Table 1.
Soil Analytical Summary
Broadway Mill Boiler 6 Environmental Assessment
Project No. 1904576

From: Krause, Caitlin <ckrause@geiconsultants.com>
Sent: Monday, April 6, 2020 10:59 AM
To: Lauridsen, Keld B - DNR
Cc: Miller, Roger; POMERVILLE, JACQUELYN; Mrotek, Melissa (GBY)
Subject: RE: Boiler 6 site
Attachments: Figure 3 - Sample Locations - Boiler 6 Area_updated 04-06-2020_rev2.pdf

Please see the revised Figure 3 associated with the Georgia-Pacific Boiler 6 NFA Request. Let us know if you have any questions.

**SAMPLE LOCATIONS
GEORGIA-PACIFIC BROADWAY MILL
BOILER #6 AREA**
1919 S. BROADWAY
CITY OF GREEN BAY
BROWN COUNTY, WISCONSIN

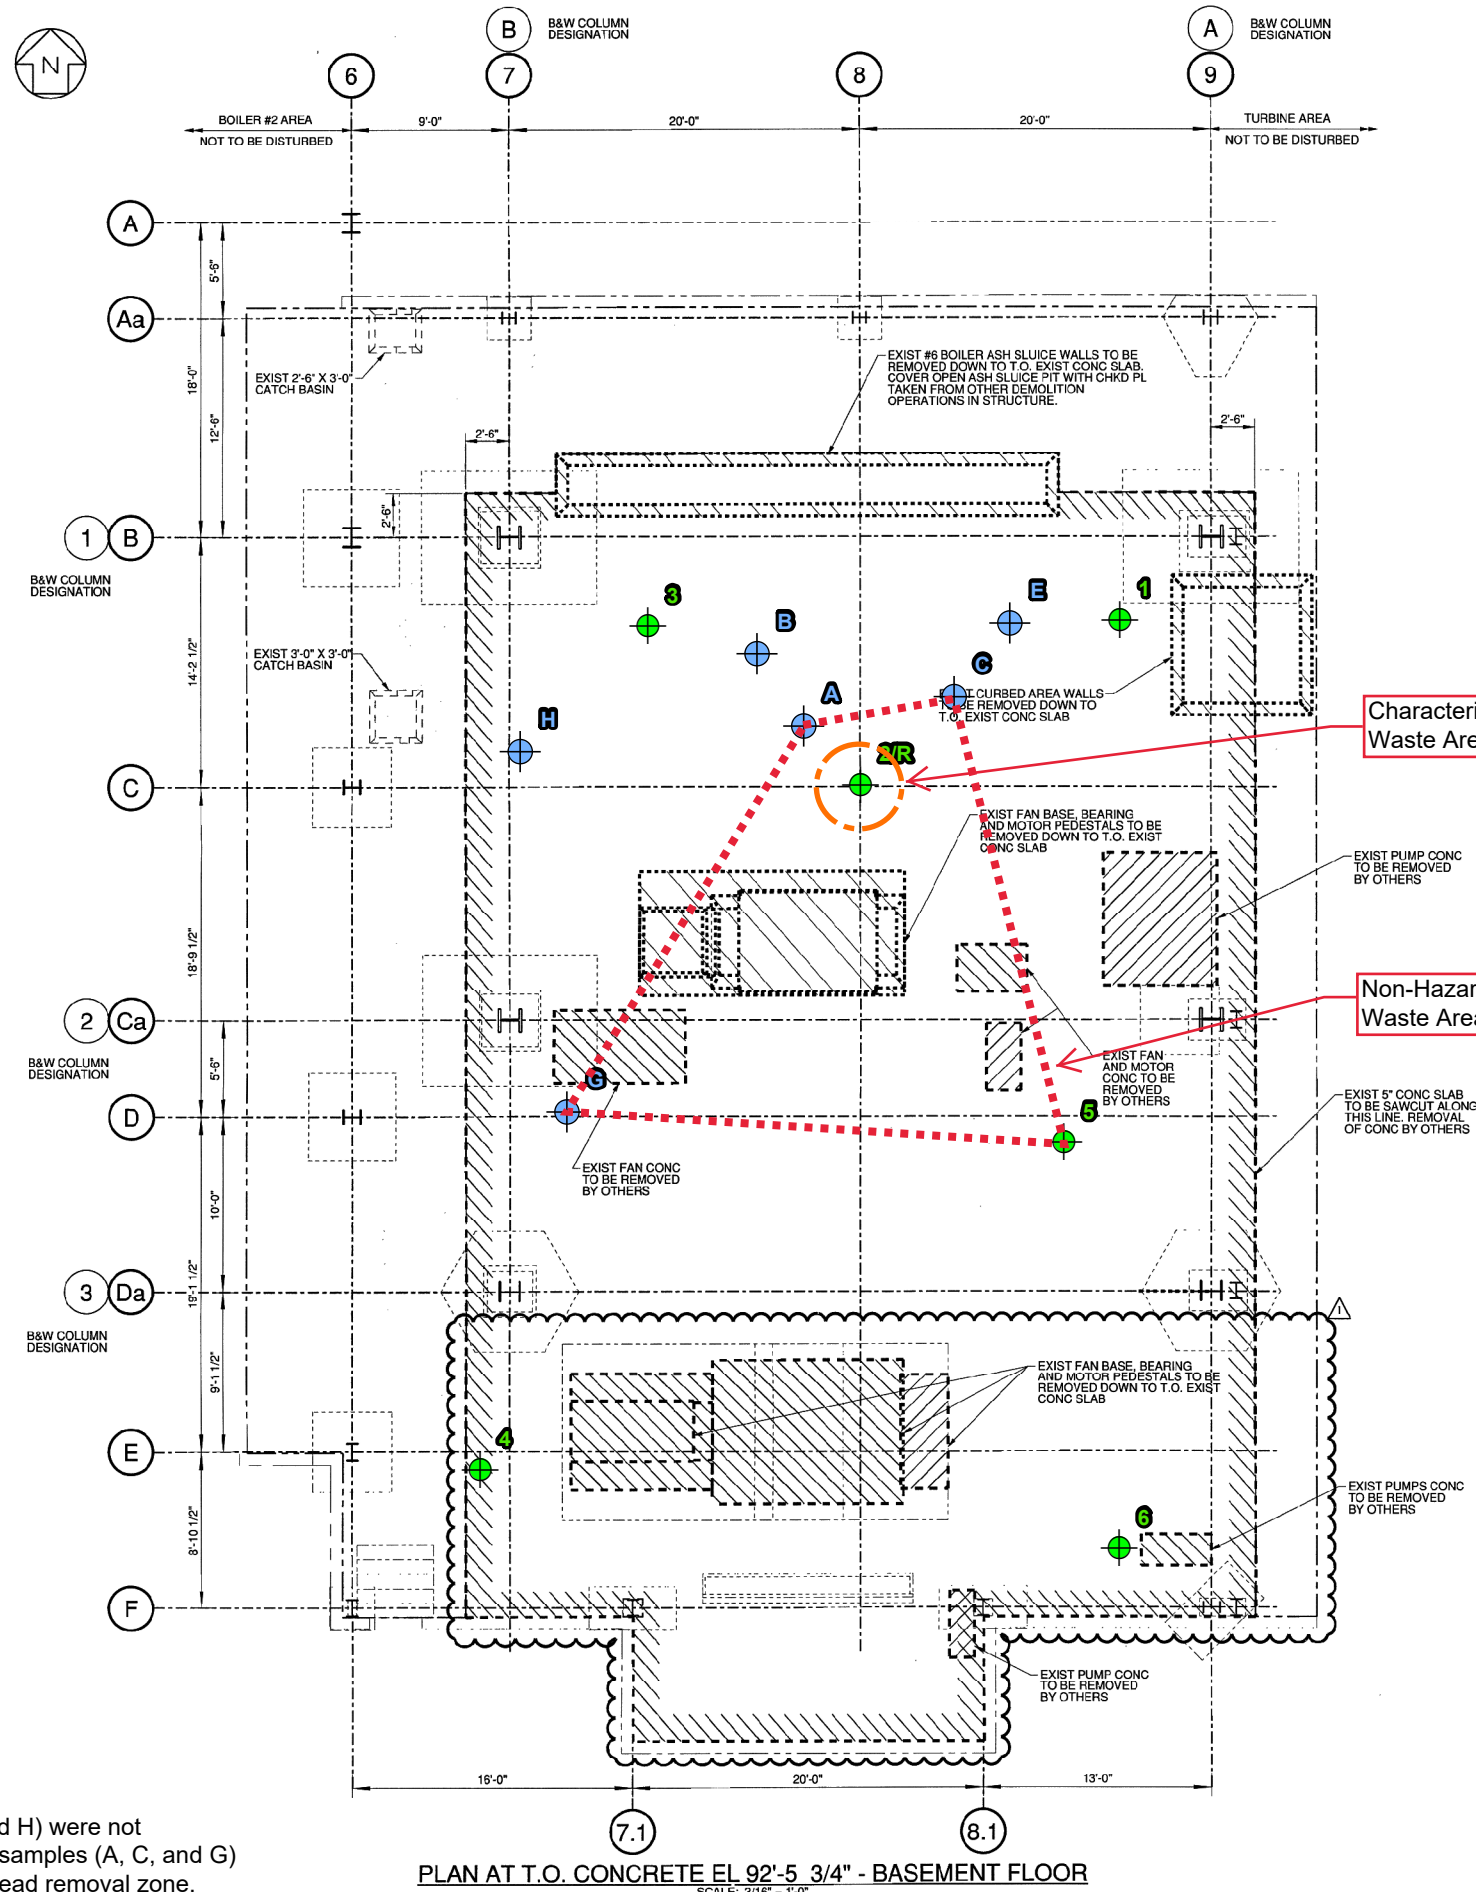
Caitlin – we will also want to note on revised Figure 3 that outer ring samples B, E, and H were not analyzed because inner ring samples were sufficient to define the soil lead removal zone.

When you send me the email with the revised map, can you also mention that the “outer ring” soil samples were not analyzed.

Note:
The outer ring samples (B, E, and H) were not analyzed because the inner ring samples (A, C, and G) were sufficient to define the soil lead removal zone.
